15547D10

# Service Manual

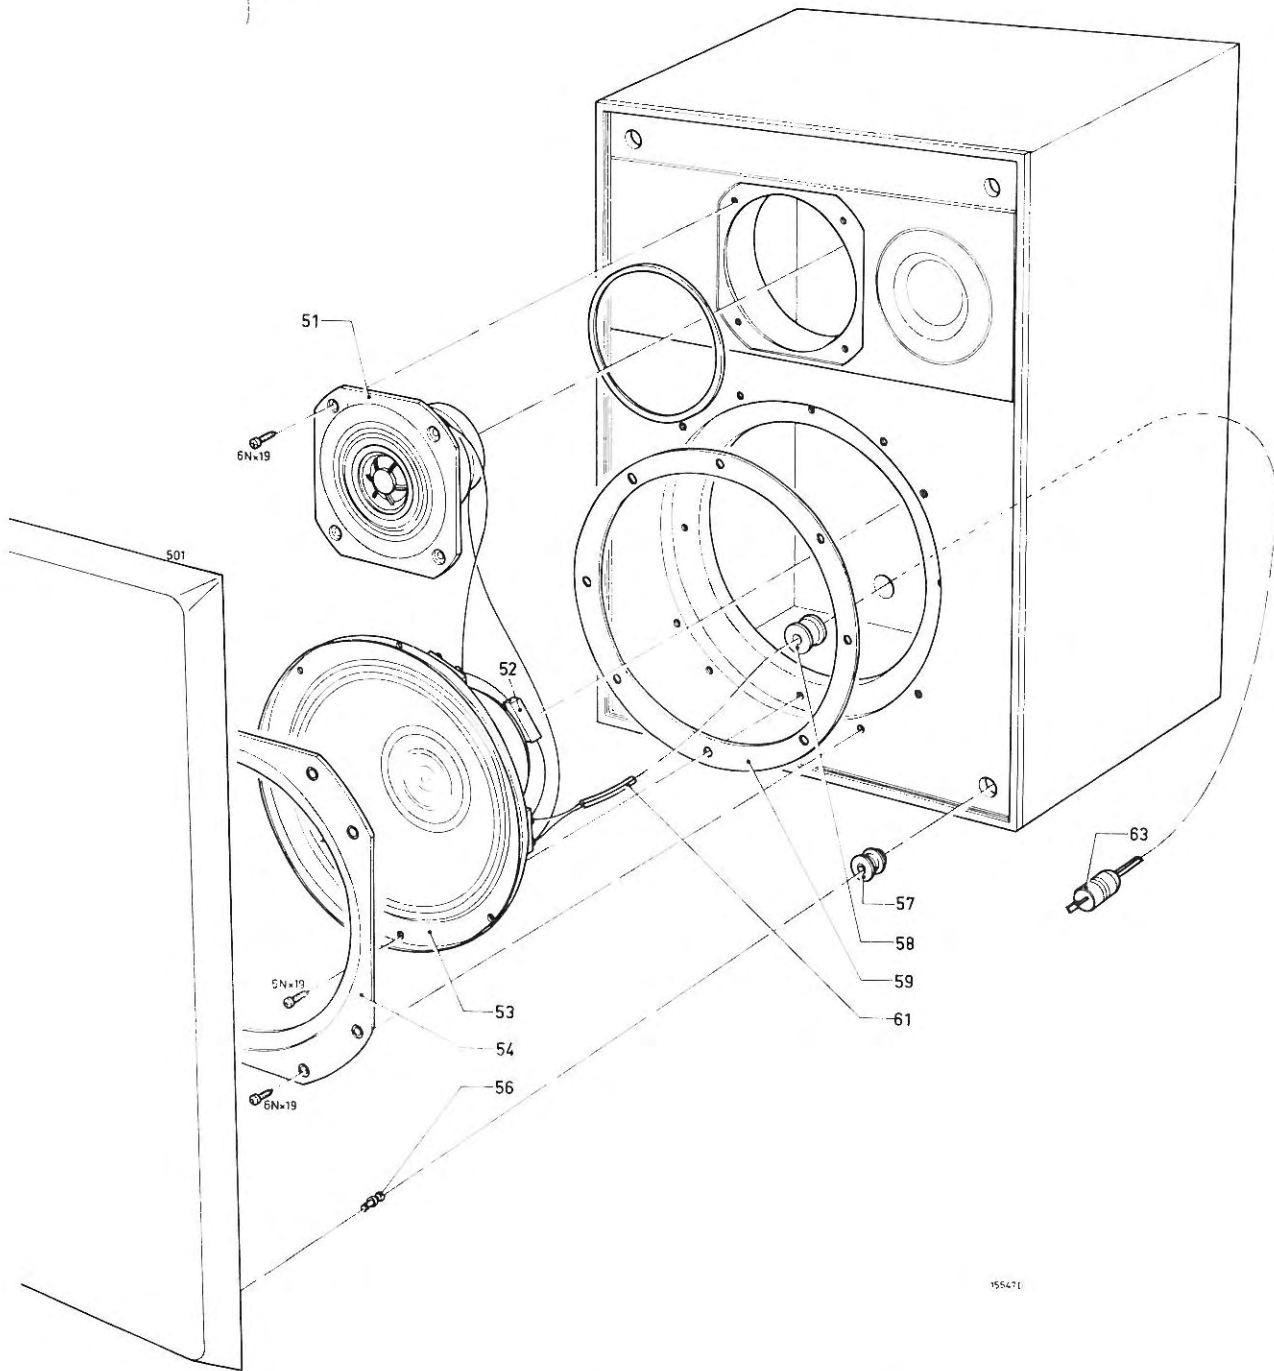
From change code PL01 the tweeter for the 22AH483/01 and the 22AH483/29 has been changed from AD0142/T8 to AD0142/T4. Code number 4822 240 70034.

From change code PL01 the tweeter for the 22AH483/00 and the 22AH483/28 has been changed from AD0142/T15 to AD0142/T8. Code number 4822 240 70028.

The bip. electrolytic capacitor 403 will be changed from 3,3  $\mu\text{F}$  63 V to 4,7  $\mu\text{F}$  63 V. Code number 4822 124 20748.

The change of electrolytic capacitor 403 only applies to the 22AH483/00 and the 22AH483/28.

Reason : improvement of spectrum pressure level.
